Access Compliance Report

Public Rights-of-Way

Intersection ID: 18350	Main Street: PROVIDENCE_RD	Cross Street: SHARON_LN	Location: SE
ADA ID: FCE11D52A098	Ramp Type: BlendTrans2	Initial Pass/Fail: Fail	Overall Compliance: No
Severity Score: 21.25			
Codes/Mitigation Info/Possible Solution		Field Measurements/Component Compliance

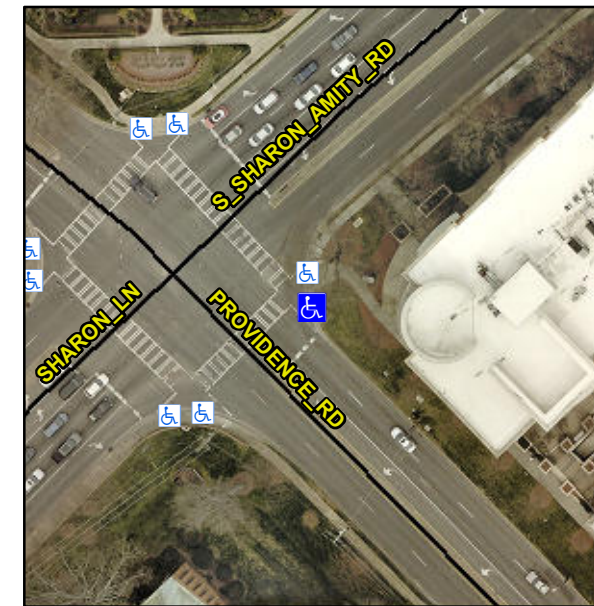
Not Found, R304.5.1, R304.5.3

Compliance	Description	Data	Compliance	Description	Data
N/A	Ramp Length (in)	60.0	Yes	BlendTrans Slope (%)	4.2
No	Ramp Width (in)	45.0	No	BlendTrans XSlope (%)	5.3
N/A	Flare Type LT	N/A	N/A	Flare Type RT	N/A
N/A	Flare Slope LT (%)	N/A	N/A	Flare Slope RT (%)	N/A
N/A	Flare Traversable LT?	N/A	N/A	Flare Traversable RT?	N/A
N/A	Landing Length (in)	N/A	N/A	DWS Provided?	N/A
N/A	Landing Width (in)	N/A	N/A	DWS Contrast?	N/A
N/A	Landing Slope (%)	N/A	N/A	DWS Length (in)	N/A
N/A	Landing X Slope (%)	N/A	N/A	DWS Full Width?	N/A
N/A	Landing Curb? (Y/N)	N/A	N/A	DWS Offset (in)	N/A
N/A	Shared Landing?	N/A			
N/A	Gutter Ponding?	N/A	N/A	Gutter Slope (%)	N/A
N/A	Gutter Lip Ht (in)	N/A	N/A	Gutter X Slope (%)	N/A
N/A	Painted X Walk1?	Yes	N/A	Painted X Walk2?	N/A
	X Walk 1 Direction	To NW		X Walk 2 Direction	N/A
	X Walk 1 Width (in)	116.0		X Walk 2 Width (in)	N/A
	X Walk 1 Slope (%)	0.4		X Walk 2 Slope (%)	N/A
	X Walk 1 X Slope (%)	4.1		X Walk 2 X Slope (%)	N/A

N/A	Ramp inside XWalk1?	No	N/A	Ramp inside XWalk2?	N/A
	Road Slope (%)	4.1		Clear Space?	N/A
	Road X Slope (%)	0.4	N/A	Clear Space to XWalk (in)	N/A
N/A	Any Obstructions?	N/A	N/A	Storm Grate/Utility Hazard?	N/A
	Obstruction Type			Storm Grate/Utility Type	
		N/A			N/A
			Yes	Surface Condition? (G/P)	Good
			No	Curb Slope (%)	8.6

Remove & Replace Curb Ramp With Two New Directional Ramps or Equivalent. Restripe Crosswalk.
